**ADDENDUM NO. 3**

Date: August 21, 2023

**Project: Project #: 0146-465  
0146-465 Isador Cohen ES / Rosemont HS Security Improvements: Group 1**

**3 FENCING PLAN** SCALE 1" = 10'-0"

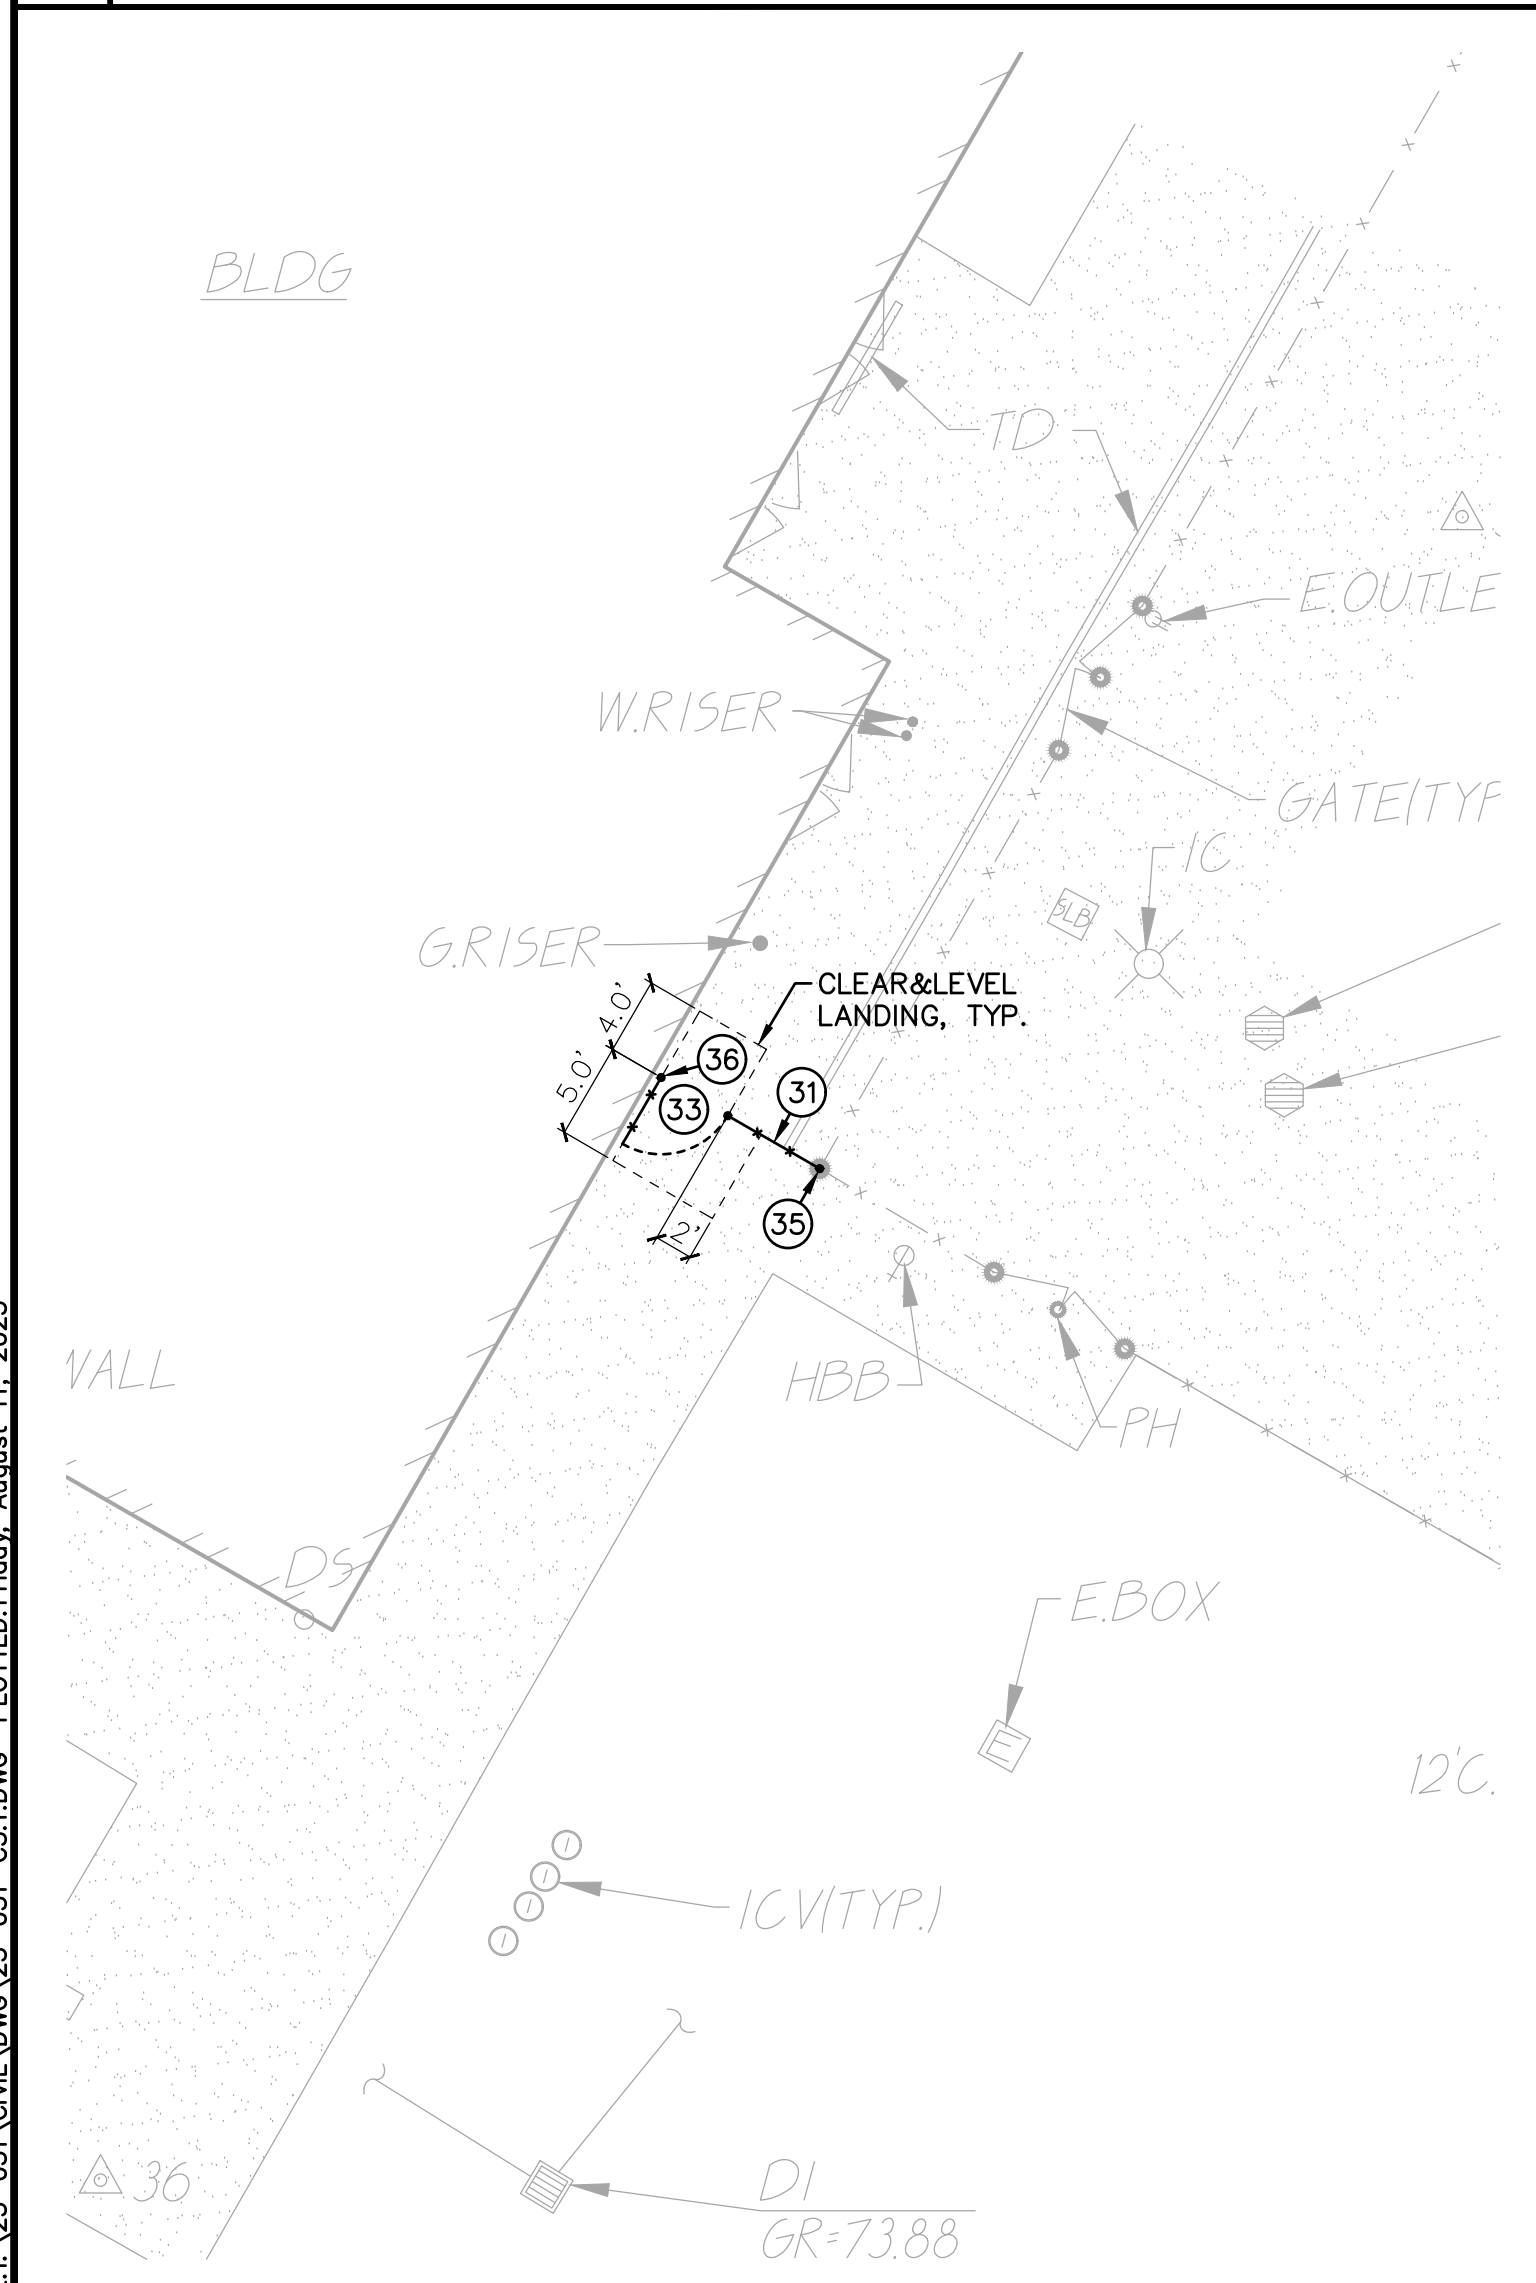
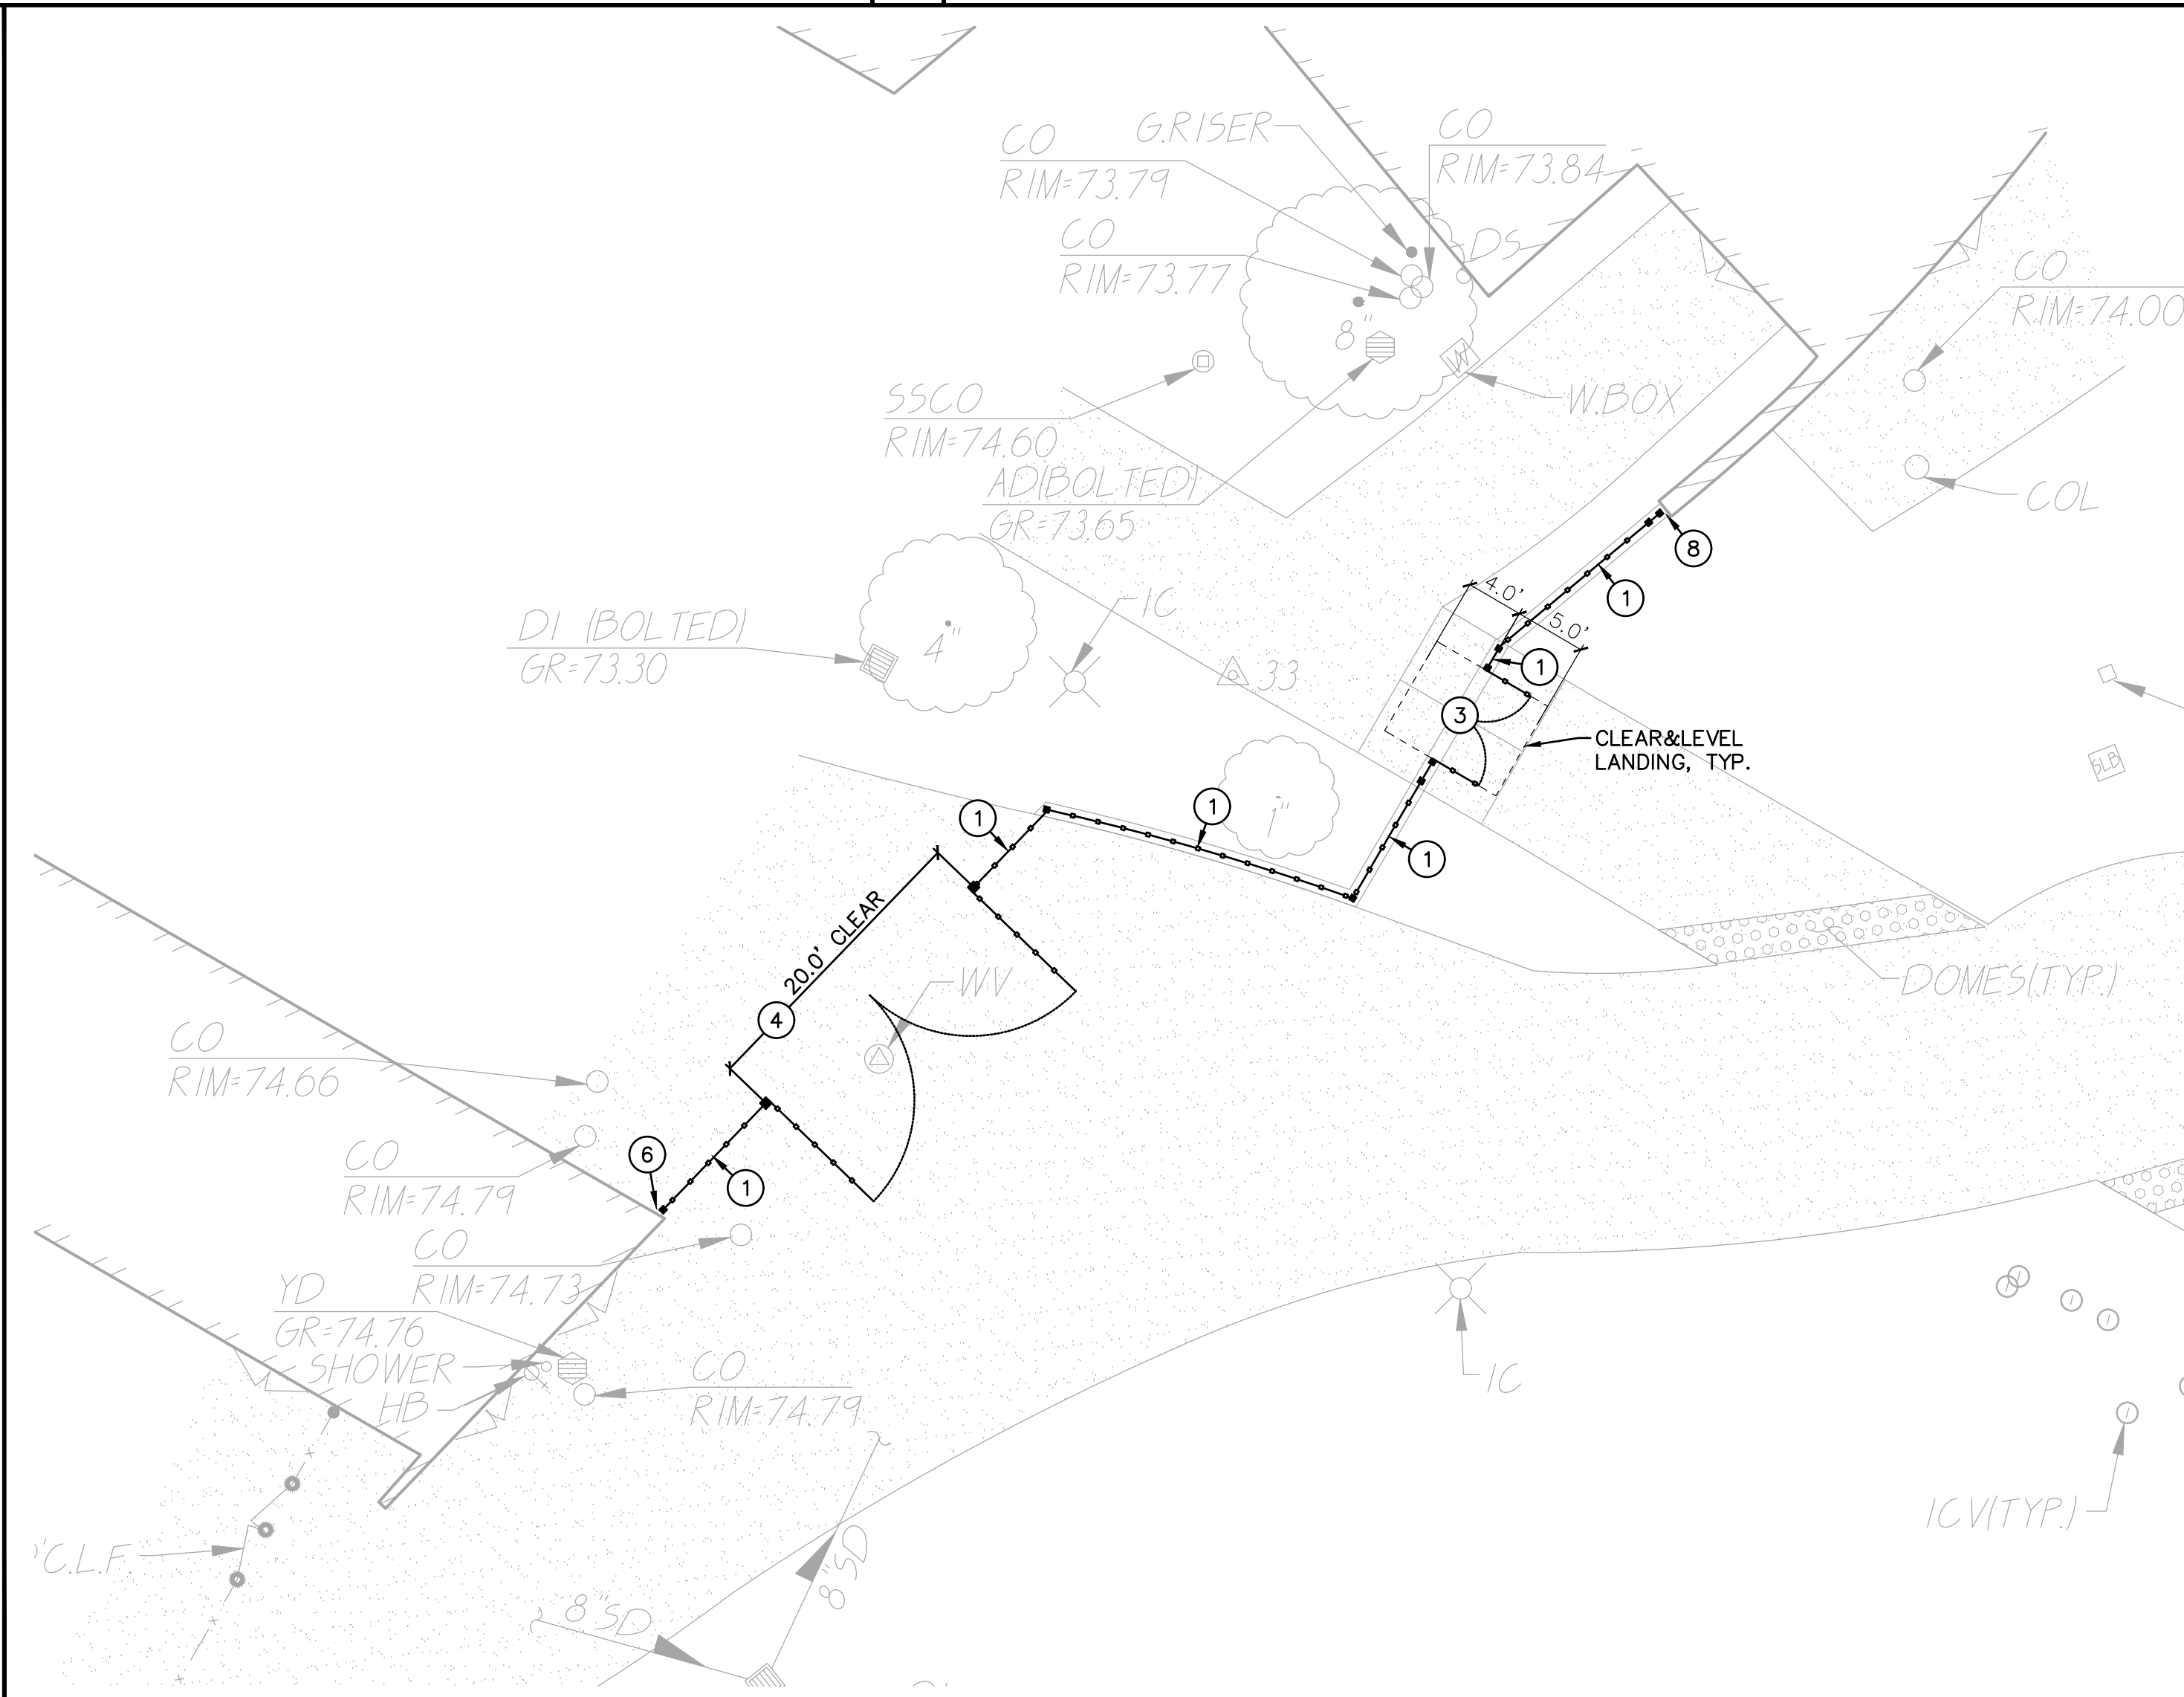
**Sheet C3.1**

- View 1 updated to change gate type in 2 locations.
- View 2 updated to change gate type in 2 locations.
- Ornamental fence note 2 updated.
- Ornamental fence note 3 updated to include additional detail reference.
- Chain link fence note 32 removed as it is no longer used.
- Chain link fence note 34 removed as it is no longer used.

5  
C4.1 EXPANSION JOINT NO SCALE

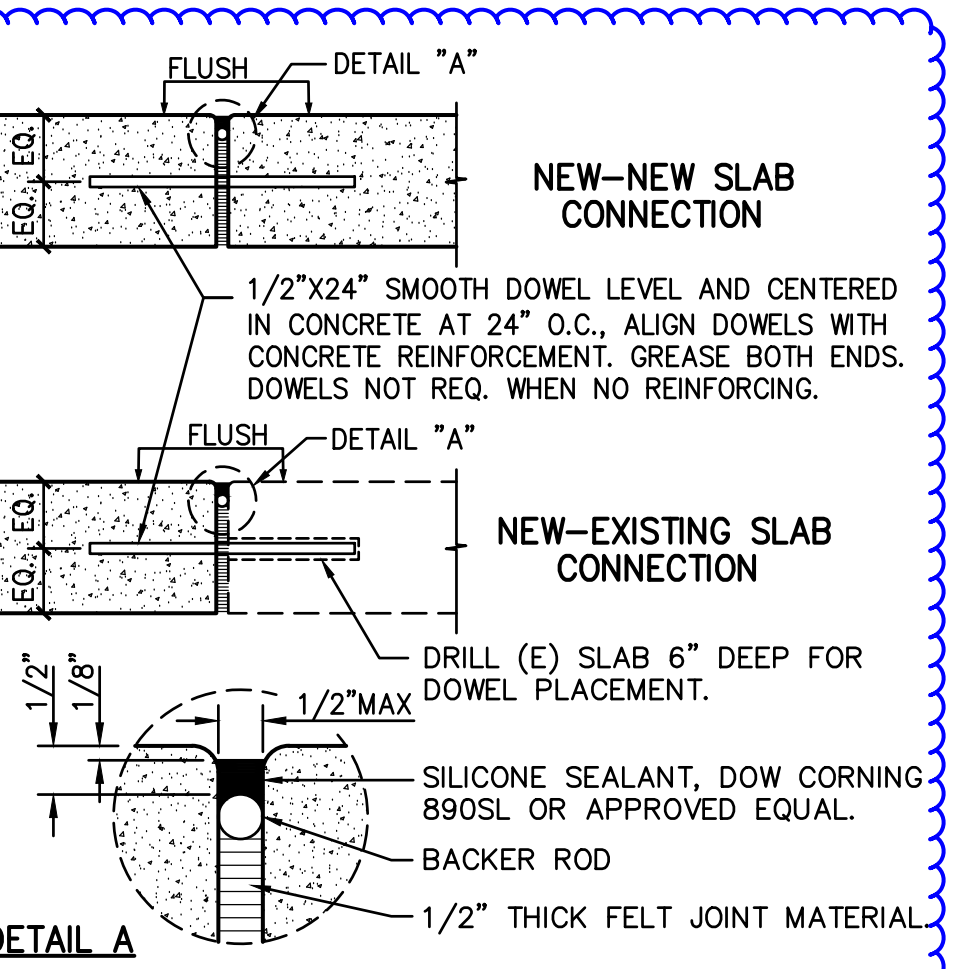
**Sheet C4.1.**

- Detail 5 updated to include additional code information.
